Before the
FEDERAL COMMUNICATIONS COMMISSION
Washington, D.C. 20554

In the Matter of)	
)	
Request for Declaratory Ruling by)	WT Docket No. 07-121
Wireless Strategies, Inc. Regarding)	DA 07-2684
Coordination of Microwave Links)	
Under Part 101 of the Commission's Rules)	
)

Comments of the Society of Broadcast Engineers, Inc.

SBE Comments: WT Docket 07-121 Fixed Microwave Antennas Having Distributed Radiating Elements

Derivation of a Radiation Pattern Envelope

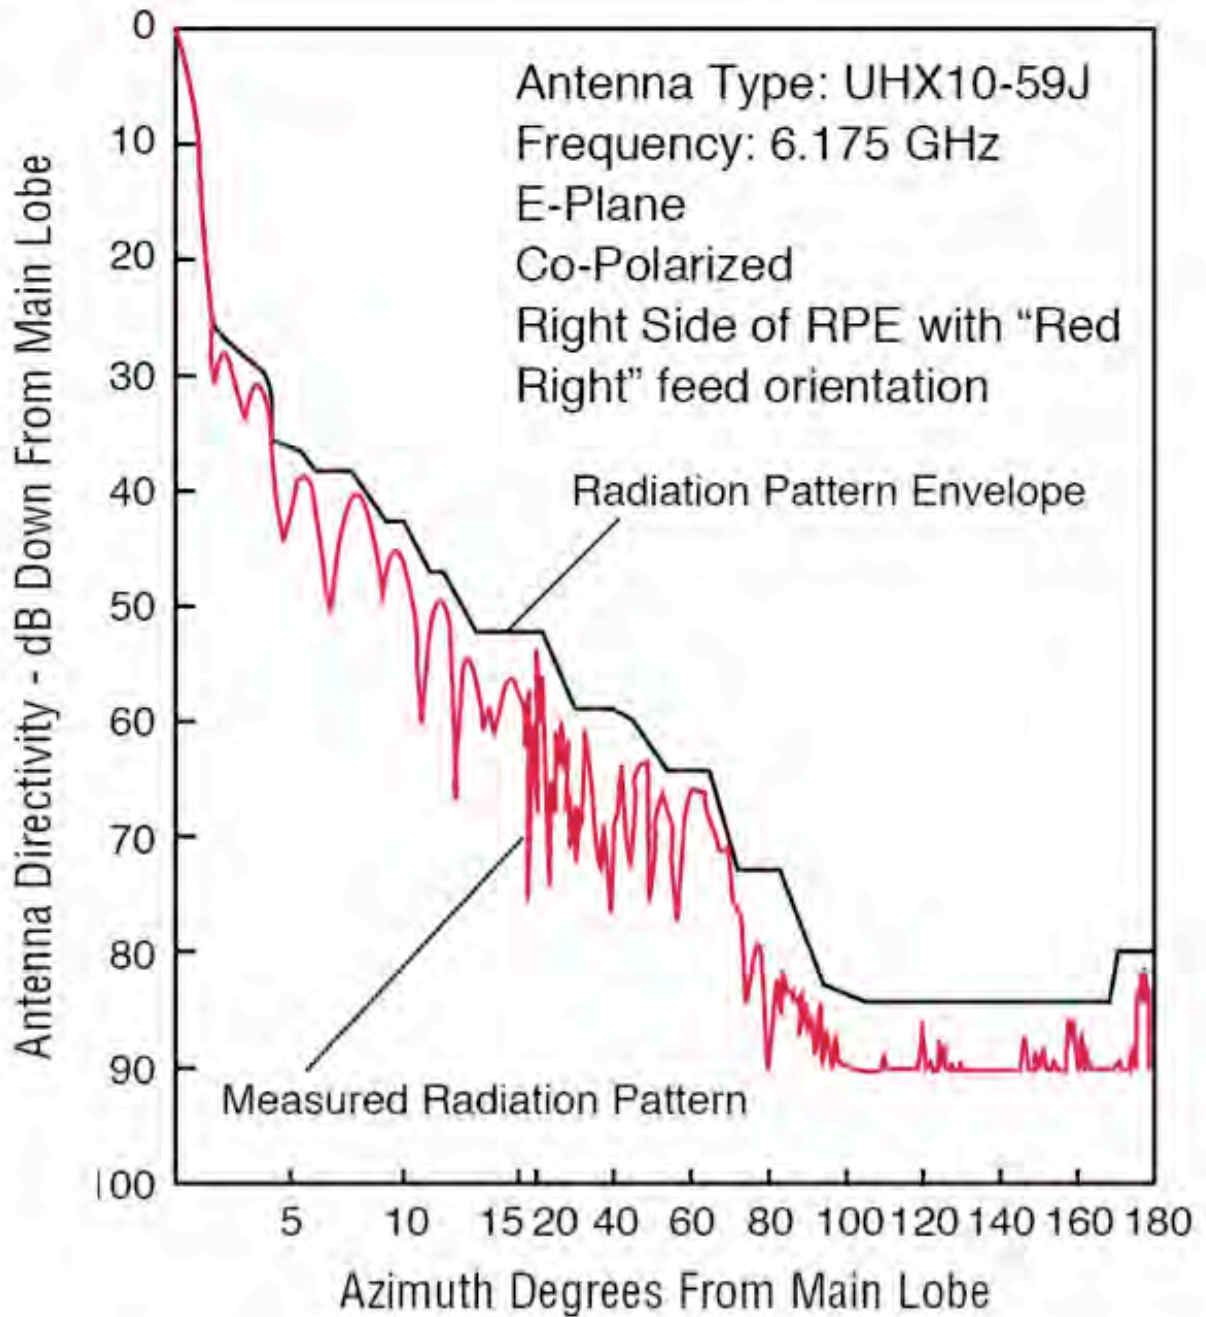
2A. The proposal assumes that there is always some headroom between the actual side lobe amplitudes of a parabolic dish and the manufacturer's published radiation pattern envelope (RPE). SBE does not believe that this is the case. Rather, for each step level of the RPE, there is

likely at least one side lobe that has the same, or nearly the same, amplitude as the RPE limit. See the attached Figure 1.

2B. The proposal ignores that the reason manufacturers of parabolic microwave antennas publish an RPE instead of the actual pattern of the side lobes is to allow for manufacturing tolerances. Some dishes may have the just-touching side lobe at one off-axis direction for a particular serial number antenna, whereas another serial number dish, of the same size and model number, could have the maximum side lobe at a somewhat different direction (but still not exceeding that step portion of the RPE).
